**Environmental
Planning
Commission**

**Agenda Number: 07
Project Number: 1004675
Case Number: 17EPC- 400
Hearing Date: September 14, 2017**

Staff Report

Agent	Consensus Planning
Applicant	Hajjar Management Co, INC/Vista Realty Trust
Request	Amend SPS, SPS and BP
Legal Description	Lots 1-72, P1 block A , lots 1-63 P1 block B plat for Vista de la Luz, Tract K1 and K-2 Vista de la Luz Commercial
Location	Southwest Corner of Coors and Sevilla
Size	30 acres
Existing Zoning	SU-1 PRD, SU-1 for PRD and one restaurant with full service liquor
Proposed Zoning	same

STREET TREE REQUIREMENTS

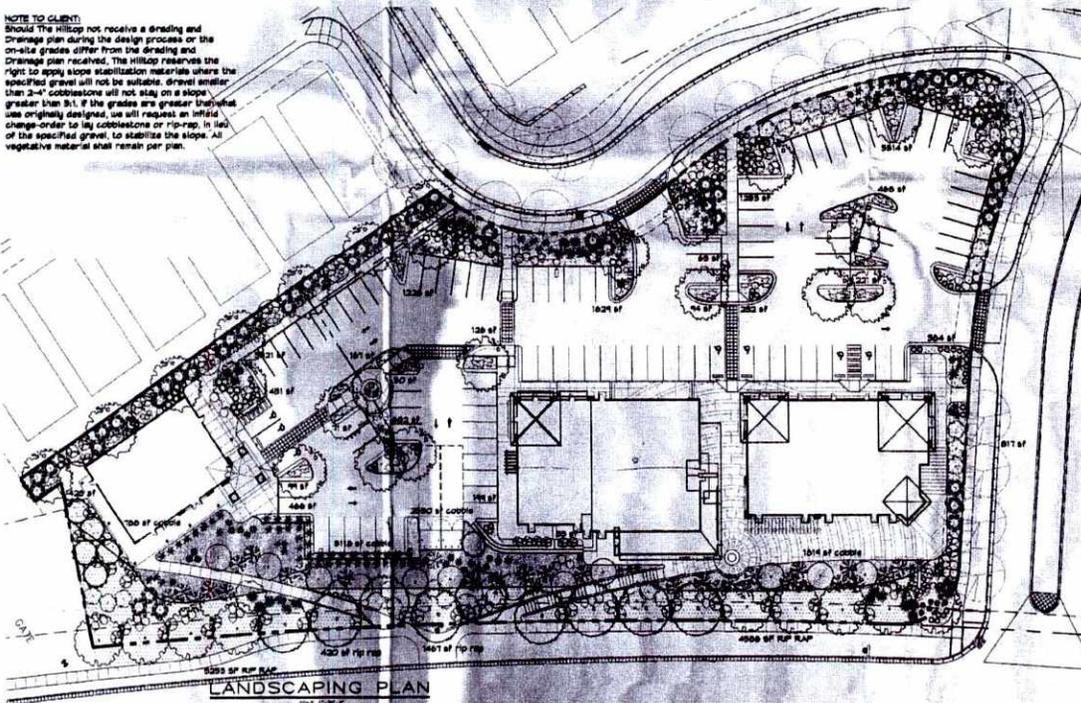
I note on Sheet LS-101 of the proposed amendment to the Site Plan for Subdivision for this project that eight new street trees are being proposed for the area between front of sidewalk and back of curb on the Coors Boulevard frontage. This was surprising, as I understand that the right-of-way of Coors is held by the State; that there is no City requirement to apply the Street Tree Ordinance to a state highway, and; that such would be a site plan element that the City could not enforce on state property.
